This document was prepared by Yong Kim and Geoff Garner.

Revision 7, November 6, 2011

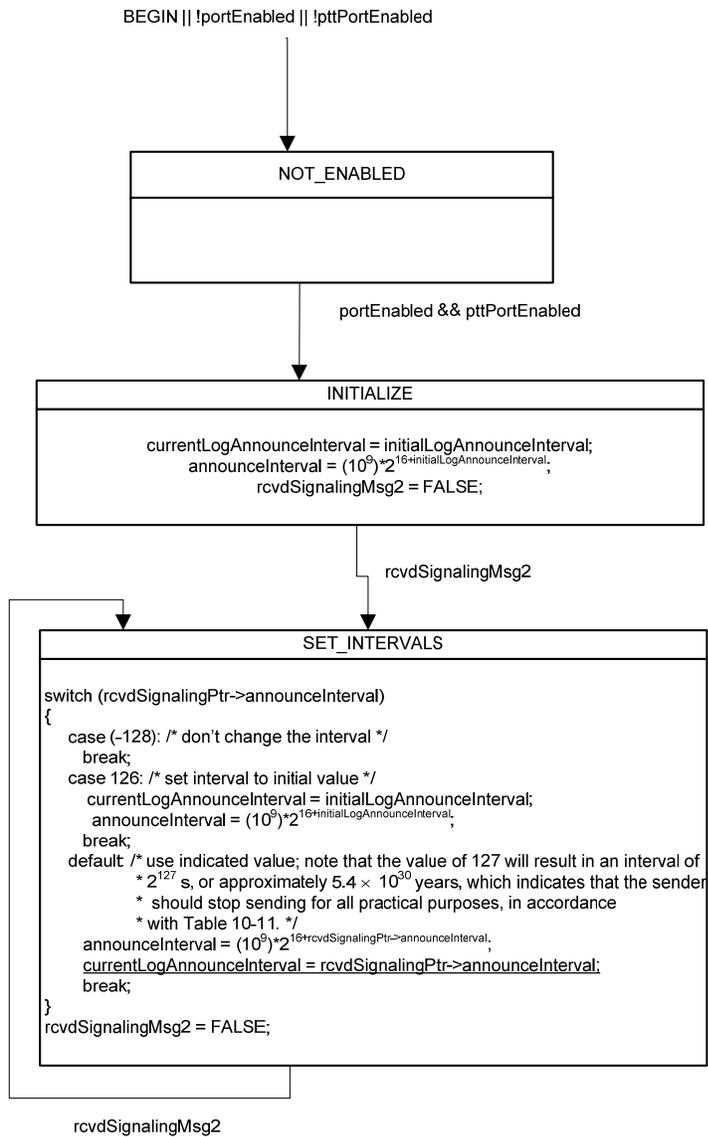
Change the Figure of 10-16, as shown

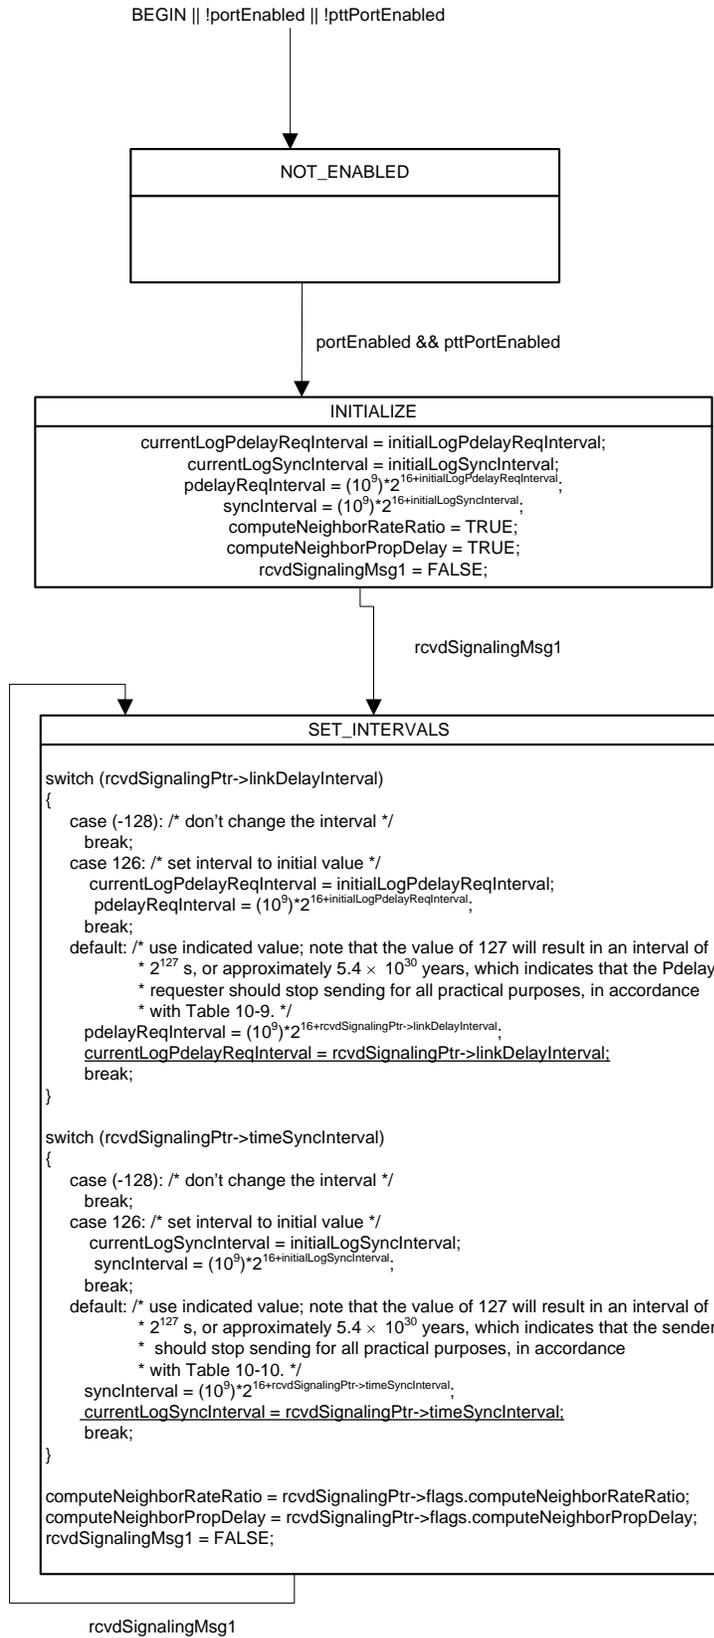
Change the Figure of 11-10, as shown

Figure B.3 – PTPDEV limit corresponding to wander generation requirement of Figure B.1

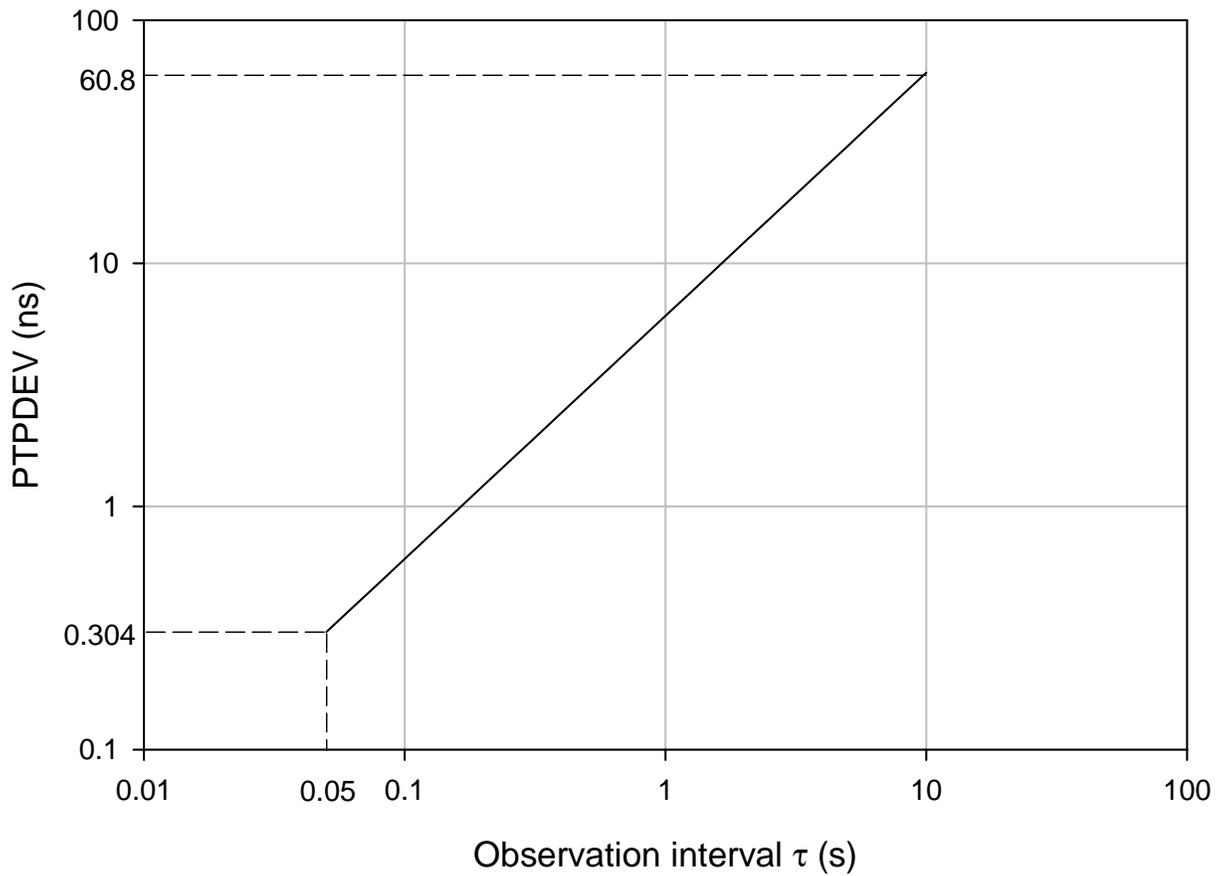
Change the Text of B.1.3.2, as shown

$$\sigma_{PTP}(\tau) = \sqrt{\frac{1}{6n^2(N-2n)} \sum_{i=1}^{N-2n} (x_{i+2n} - 2x_{i+n} + x_i)^2}, \quad n = 1, 2, \dots, \left\lfloor \frac{N-1}{2} \right\rfloor$$

$$\sigma_{PTP}(\tau) = \sqrt{\frac{1}{6(N-2n)} \sum_{i=1}^{N-2n} (x_{i+2n} - 2x_{i+n} + x_i)^2} \quad , \quad n = 1, 2, \dots, \left\lfloor \frac{N-1}{2} \right\rfloor$$
